SITE: 245-275 Lamarche Ave

TITLE: Geometric Road Design Redline

SCALE AT A3: NTS	DATE: 2022-12-09	DRAWN: BB	CHECKED: AL
PROJECT NO: 2022-023	DRAWING NO: 001	REVISION: 04

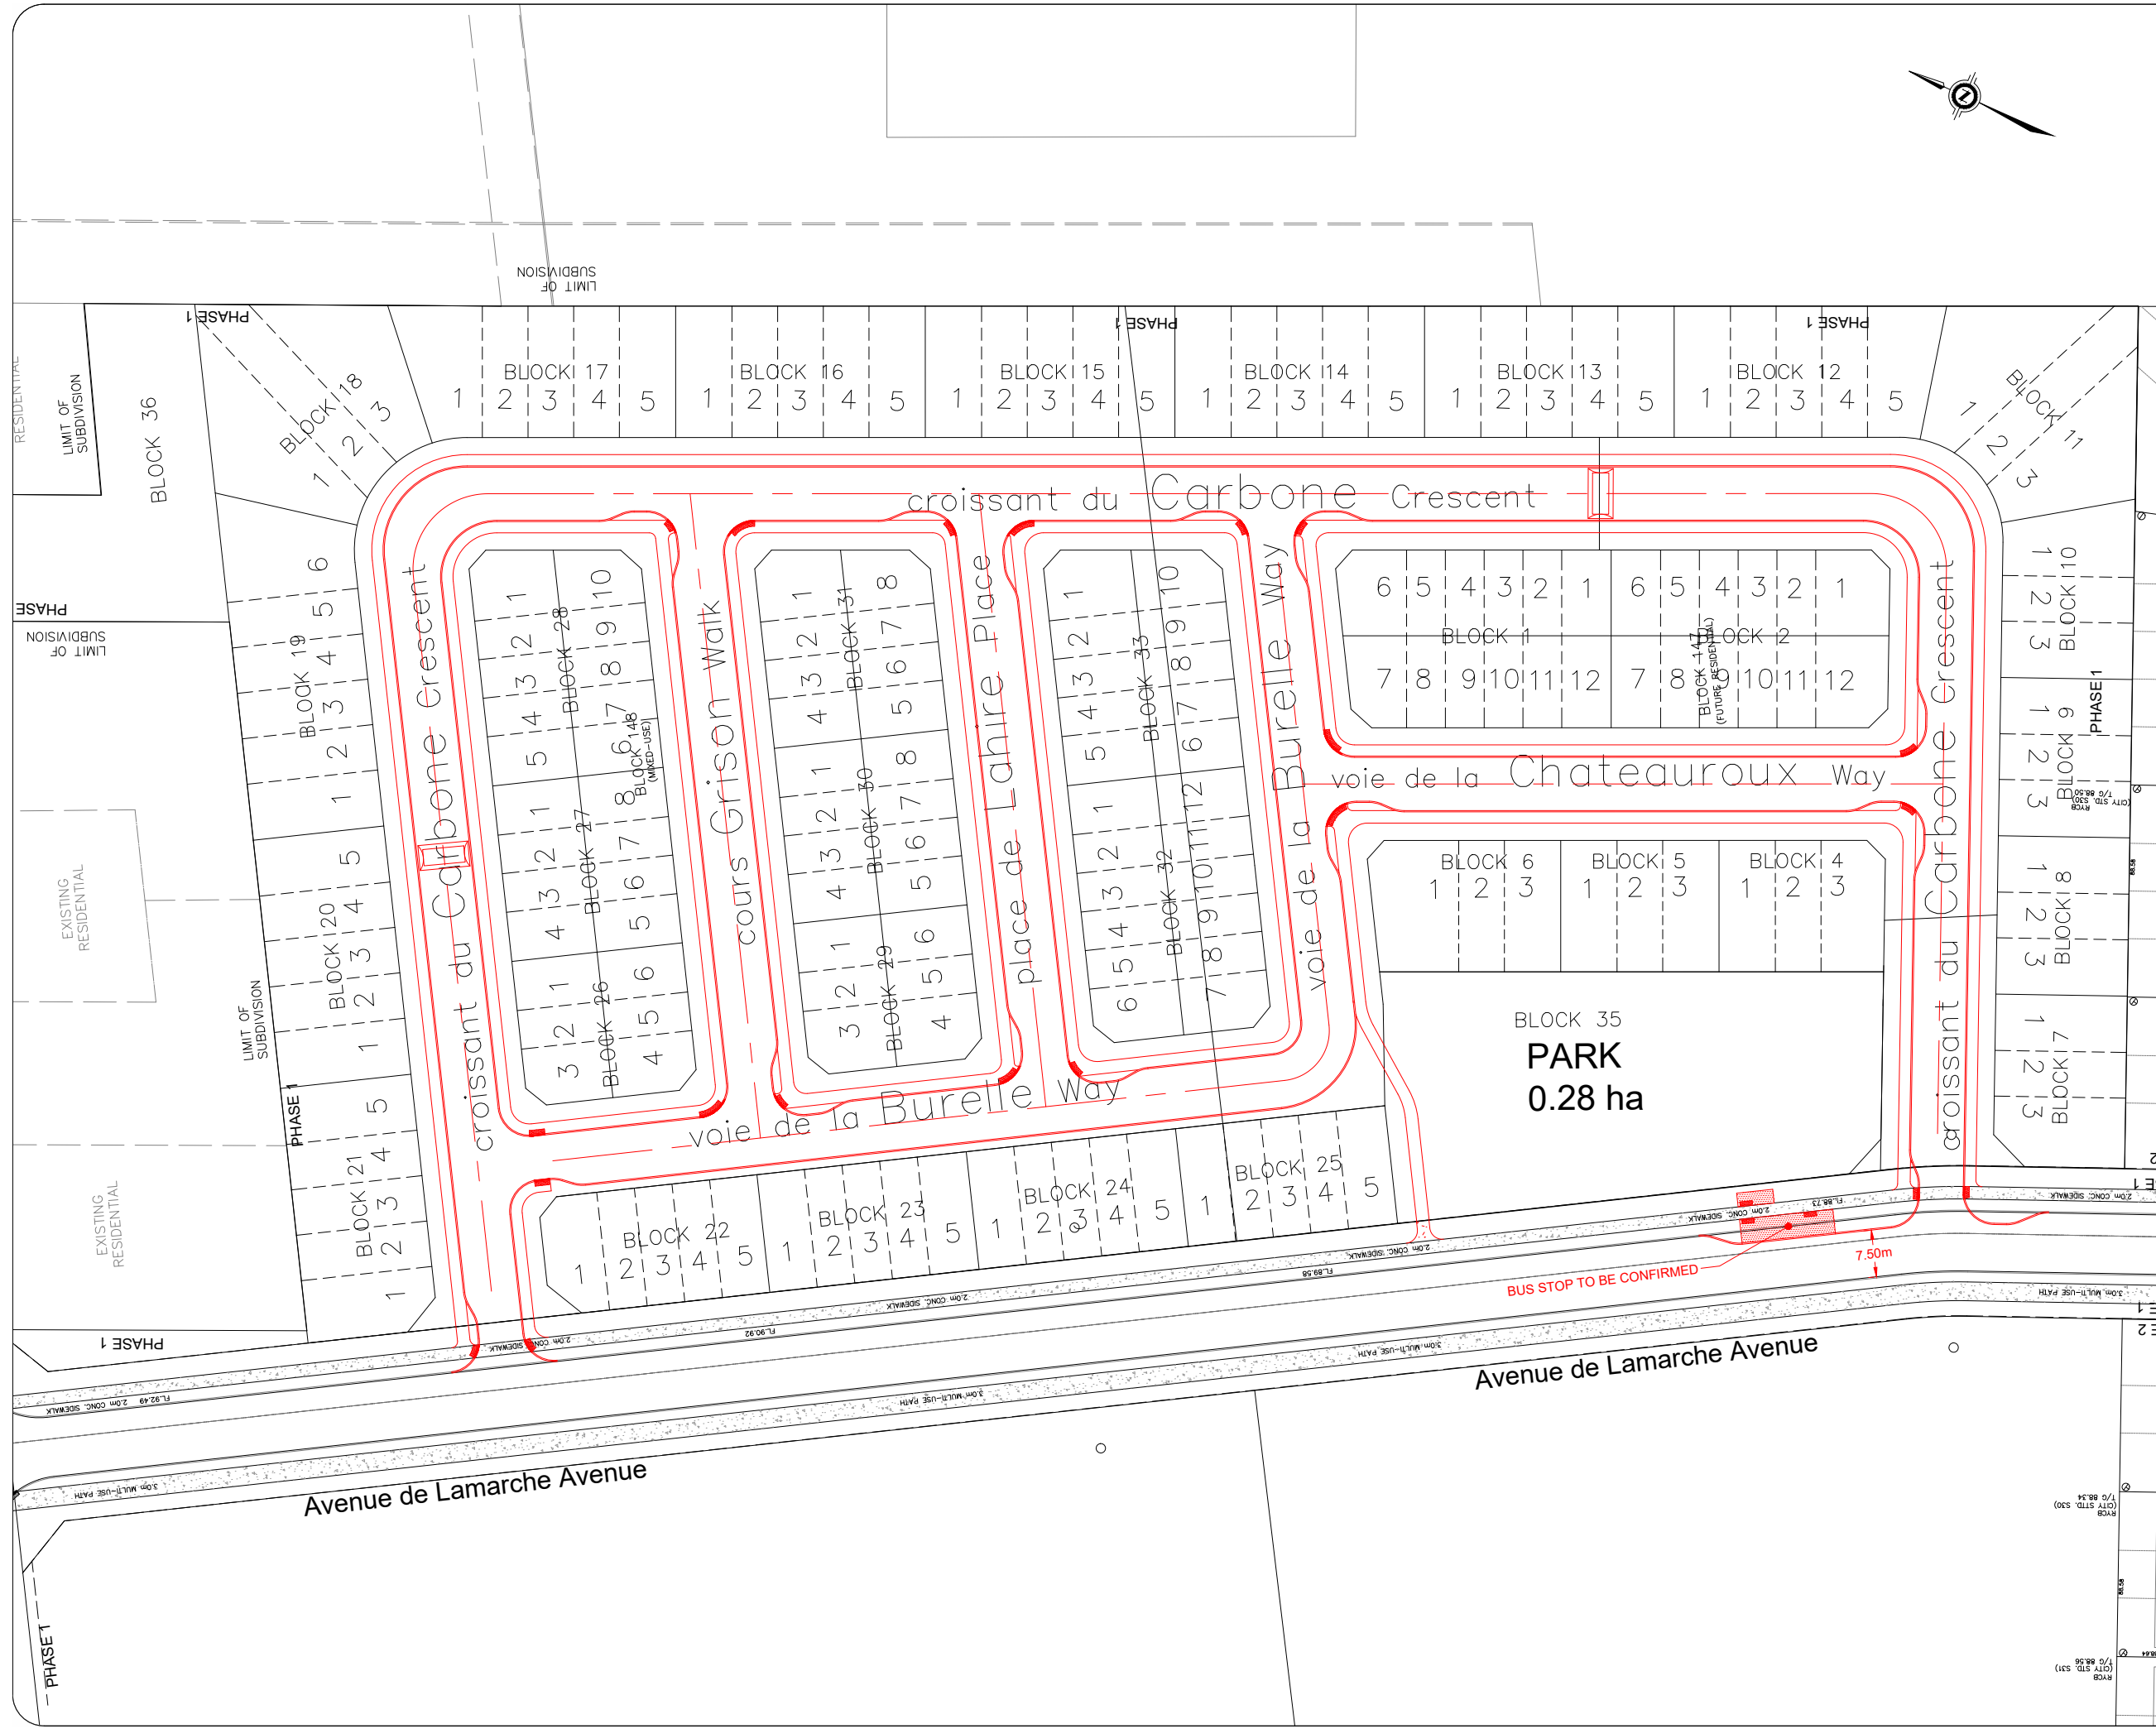
BUS STOP TO BE CONFIRMED

7.50m
